Riley Purgatory Bluff Creek Watershed District Permit Application Review

Permit No: 2023-053

Project: Helgeson Residence– The applicant is seeking an after-the-fact permit for construction of a home addition with driveway and earthen berm completed in 2015 and installation of a patio and associated landscaping completed in 2023.

Location: 6575 Pleasant View Way, Chanhassen, MN

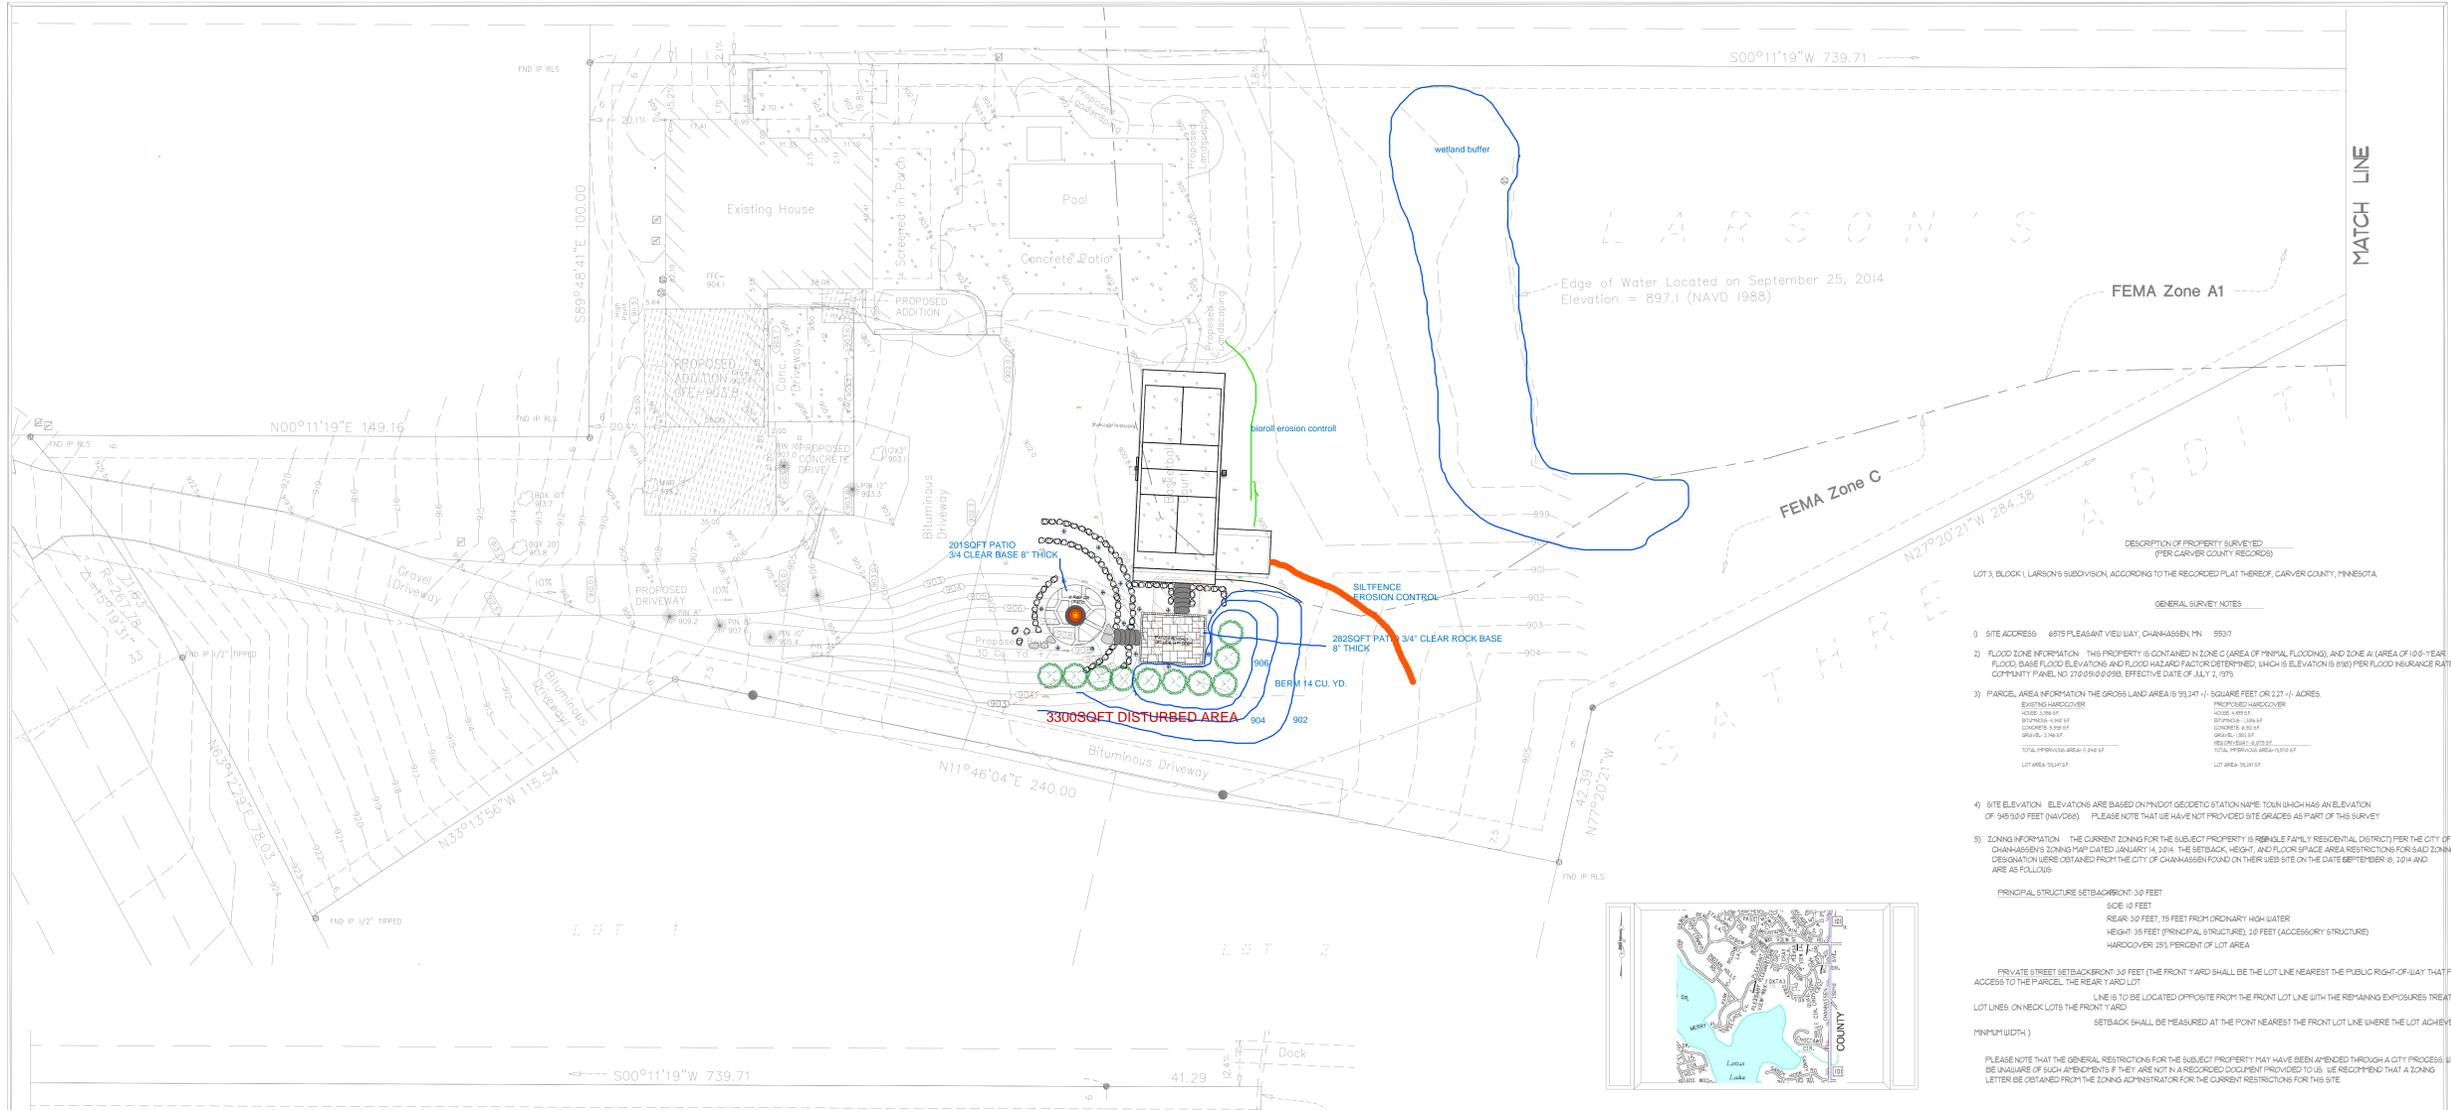
The buffer was planted with native vegetation, not yet fully established as of December 2023, thus conforming to Rule D, Subsection 3.3. The submitted plans show only the portion of the buffer that was revegetated but do not show the full extent of the buffer, which must extend along the entire edge of the delineated wetland up to the property lines.

- D1. Submit revised site plans showing the buffer extending along the entire edge of the delineated wetland up the property lines.
- D2. Buffer areas and maintenance requirements must be documented in a declaration recorded after review and approval by RPBCWD in accordance with Rule D, Subsection 3.5.

1. Buffer areas and maintenance requirements must be documented in a declaration recorded after review and approval by RPBCWD in accordance with Rule D, Subsection 3.5.
2. The applicant must provide the permit fee deposit of \$200 and replenish the same to the original amount due before the permit will be issued. As of December 31, 2023 the amount due is \$1,922.53.
